# SAN FRANCISCO PLANNING DEPARTMENT

**MEMO**

**RE:** **Review and Comment on work proposed to abate Planning Enforcement Case No. 2017-015635ENF, addressing work completed without a Certificate of Appropriateness and proposed expansion of a penthouse and addition of a roof deck and gate, Case No. 2018-009197COA.**

**Re: 1470 McAllister Street**  
**Planning Case No.: 2018-009197COA**  
**Hearing Date: March 6, 2019**  
**Our File No.: 10403.02**

3 AS BUILT SECOND FLOOR PLAN  
SCALE: 3/16" = 1'-0"

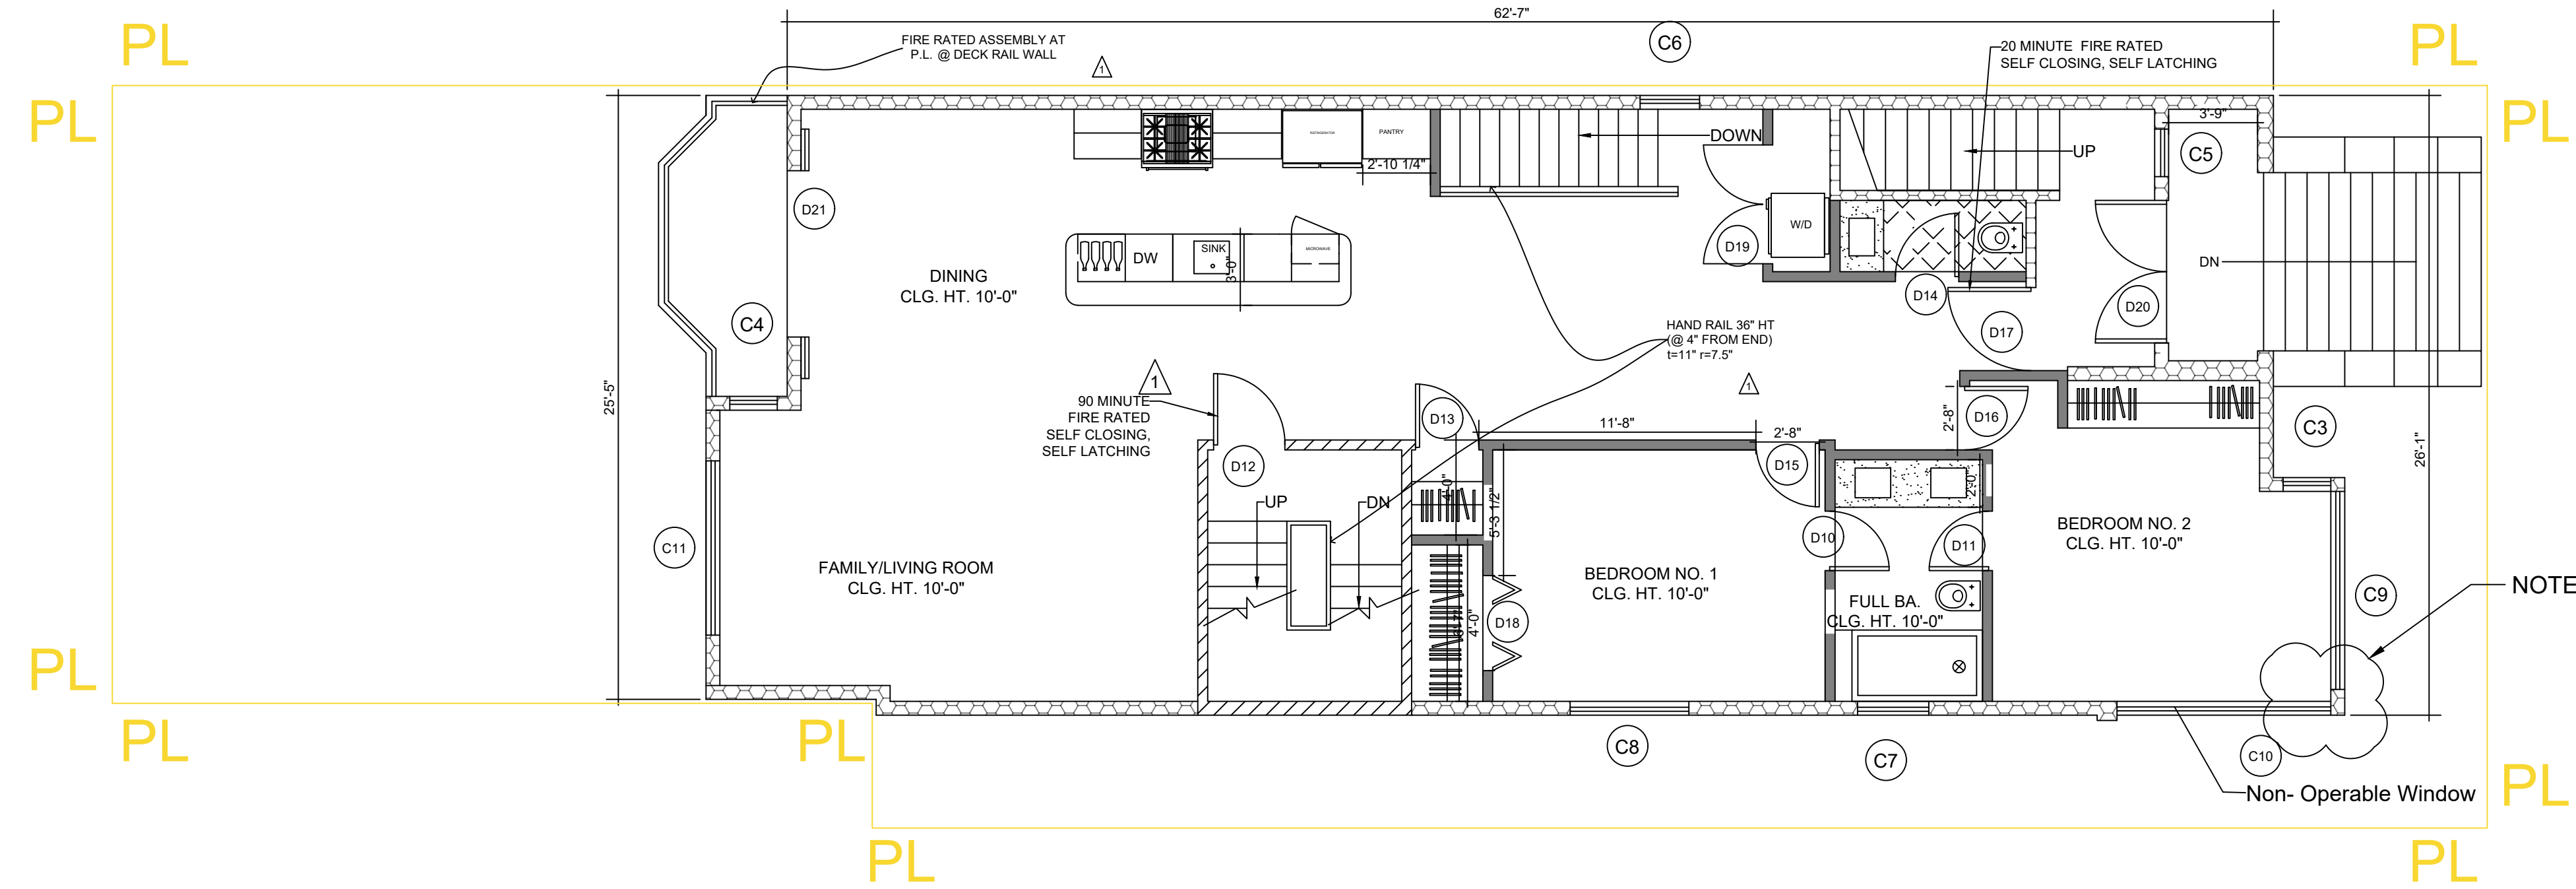
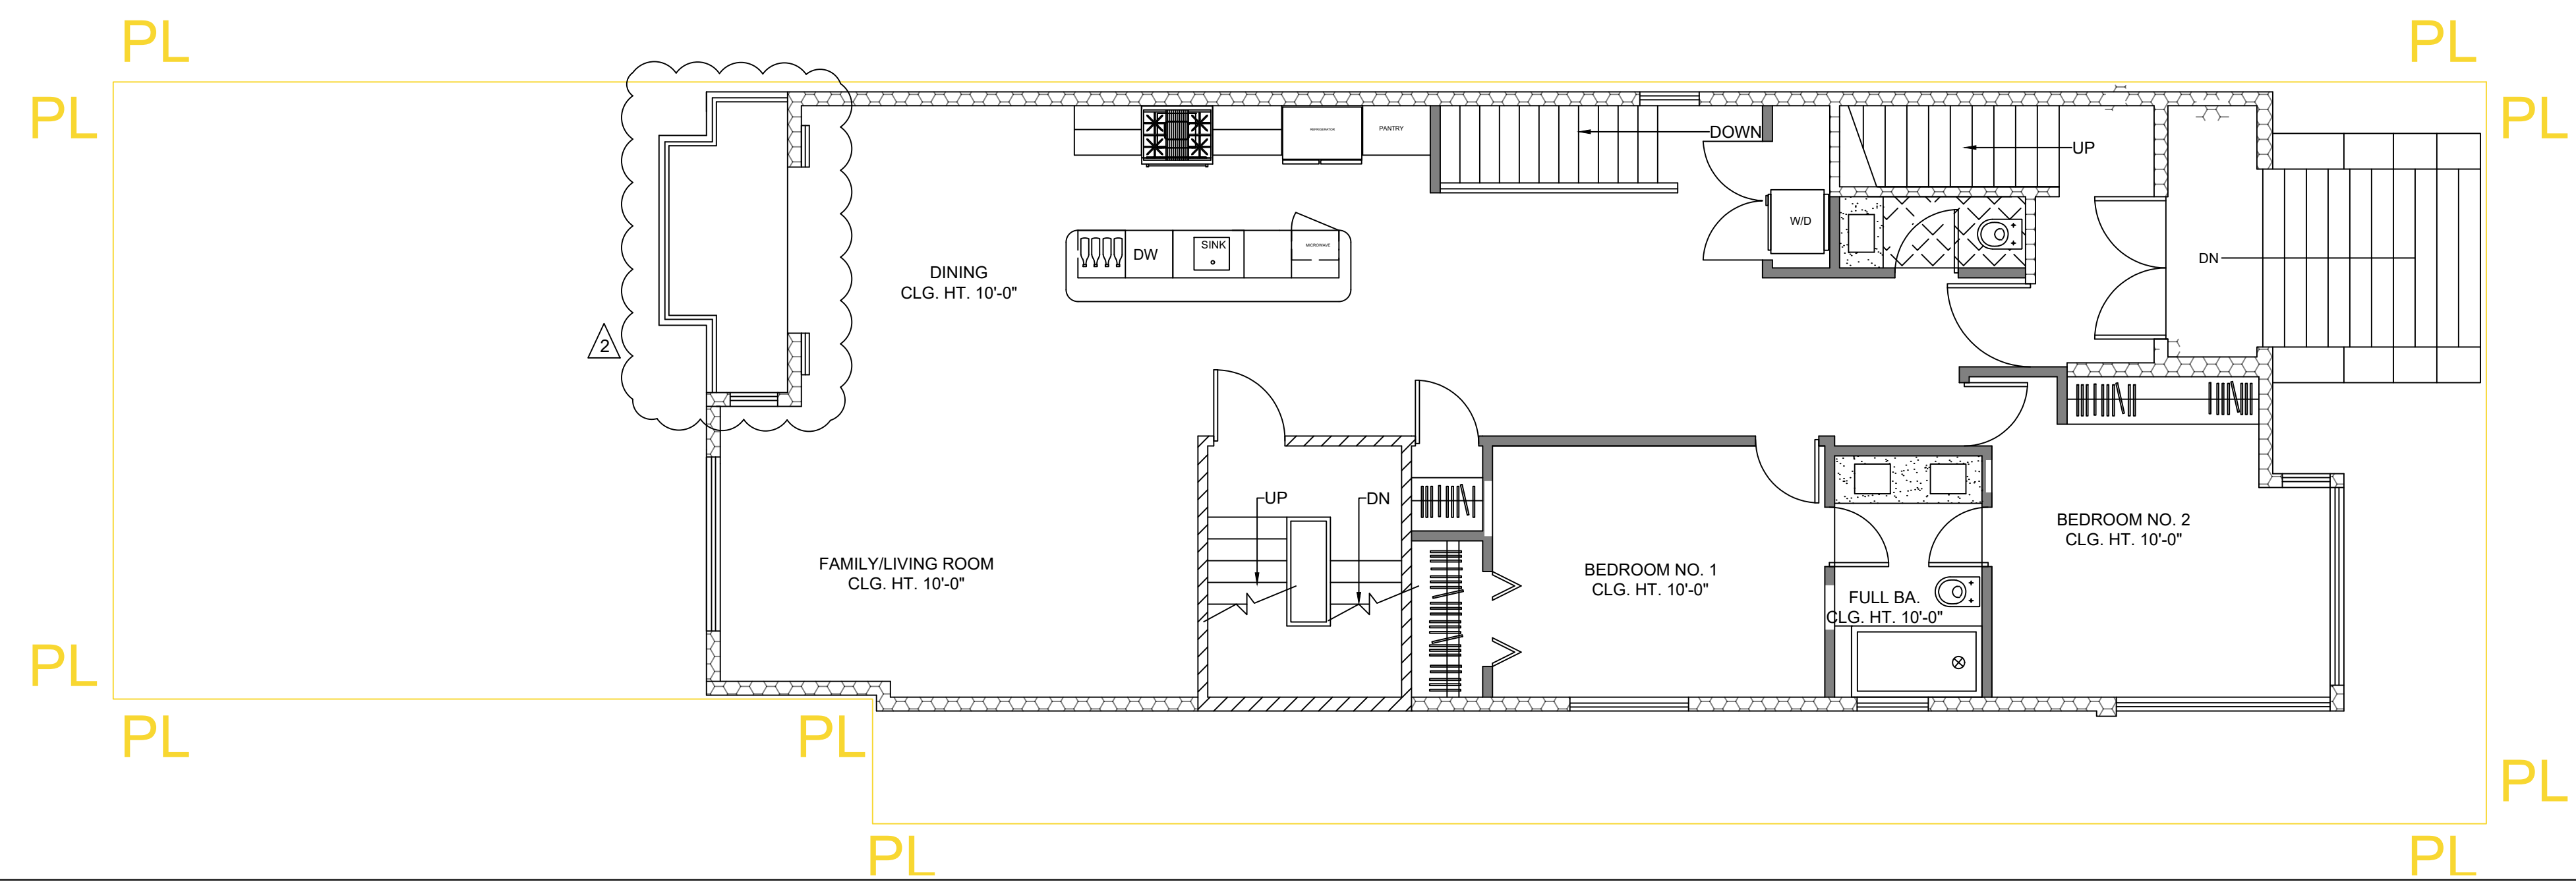
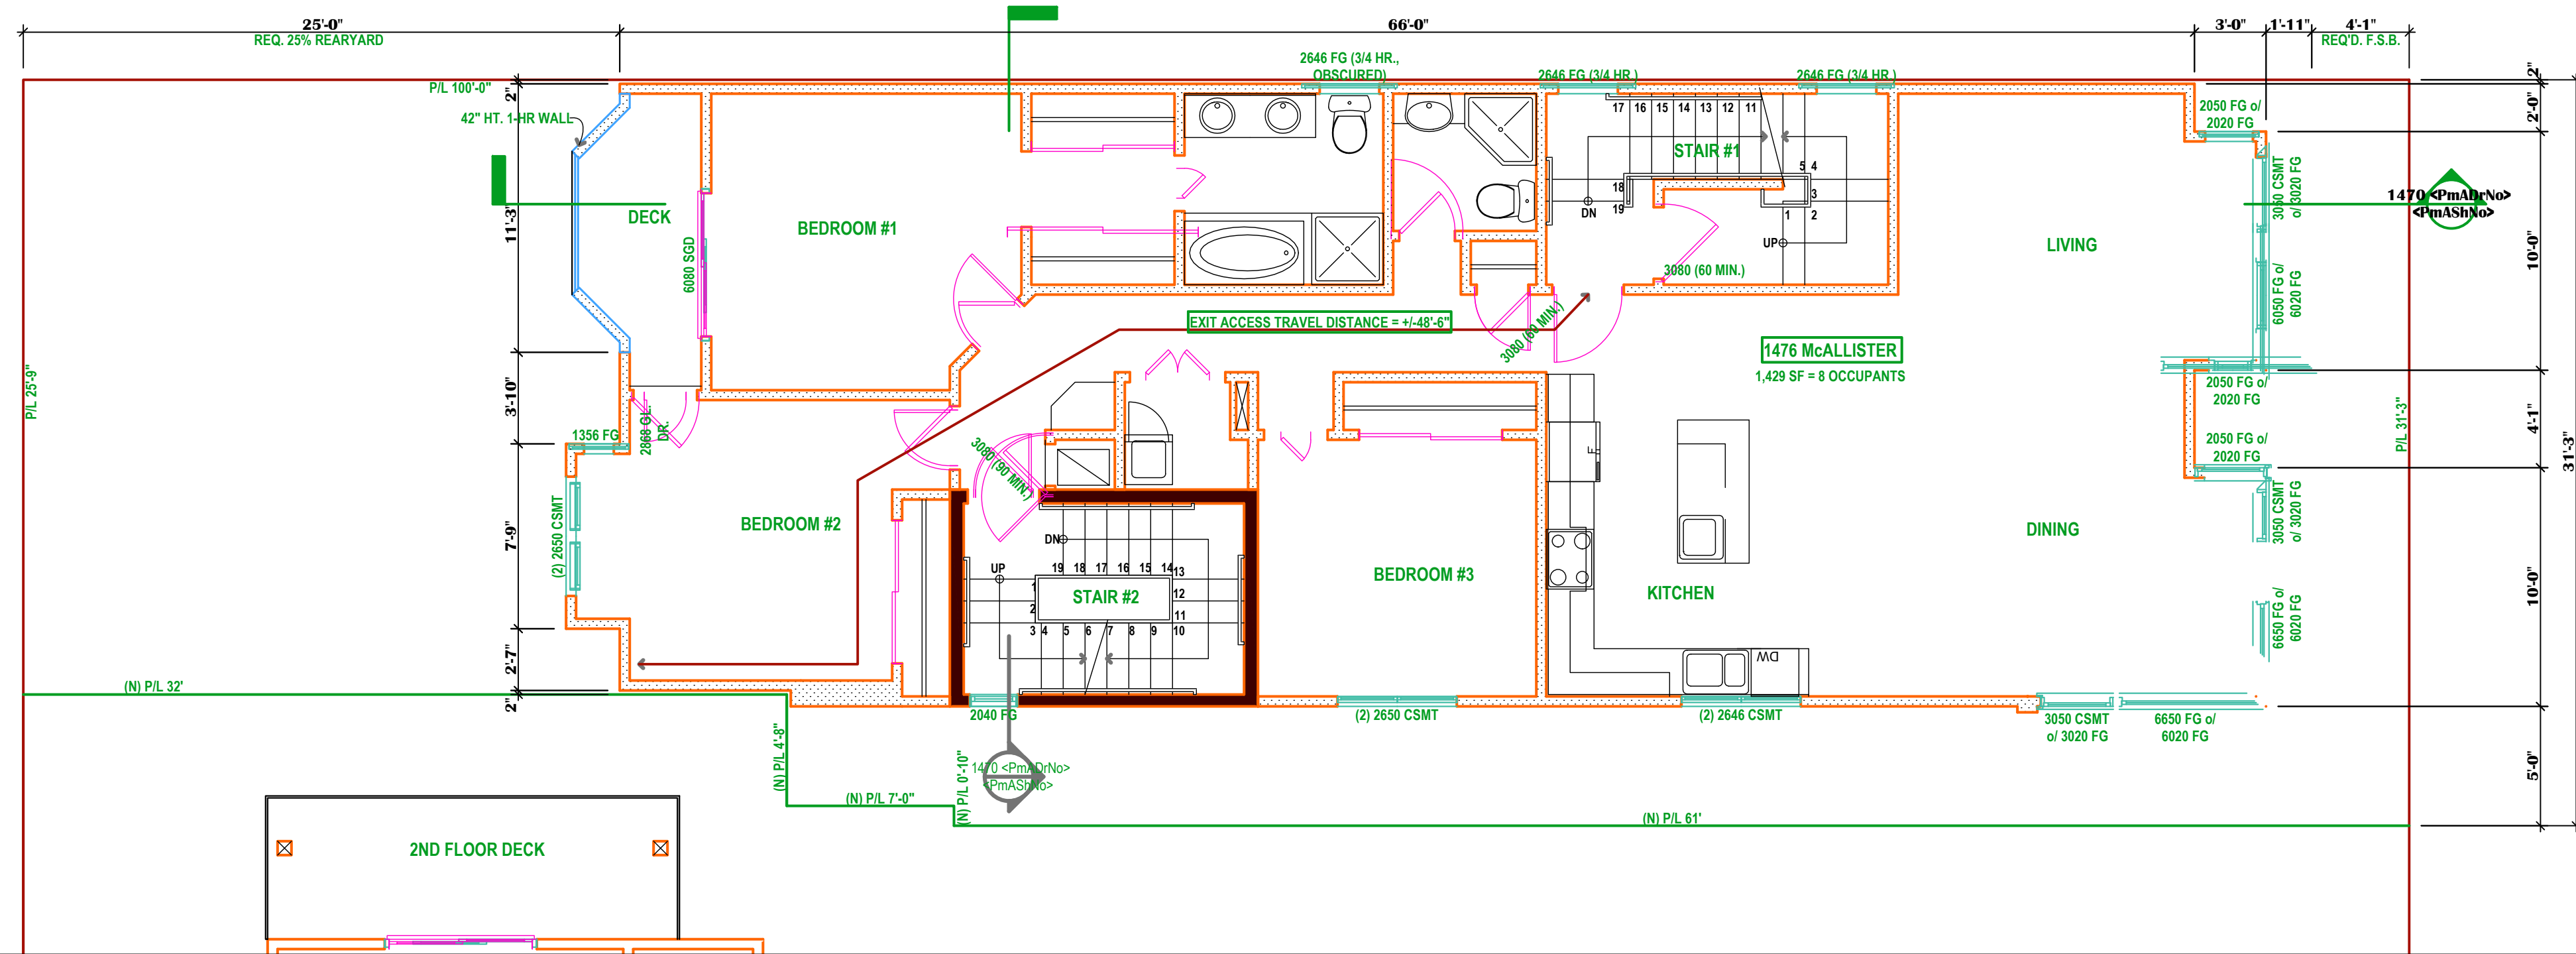
- **Entrance Sidelights.** The approved floor plans indicate one sidelight on the right of the front entry door. (*See Sheet A2.3 [Second Floor Plans].*) The constructed multi-family building does not have a sidelight there because there is a moment frame column installed there precluding the ability to install a sidelight there. Further, a sidelight on the left of the front entry door is not possible as 1470 McAllister Street has a demising wall there. (*See Sheet A2.3 [Approved Second Floor Plans].*)
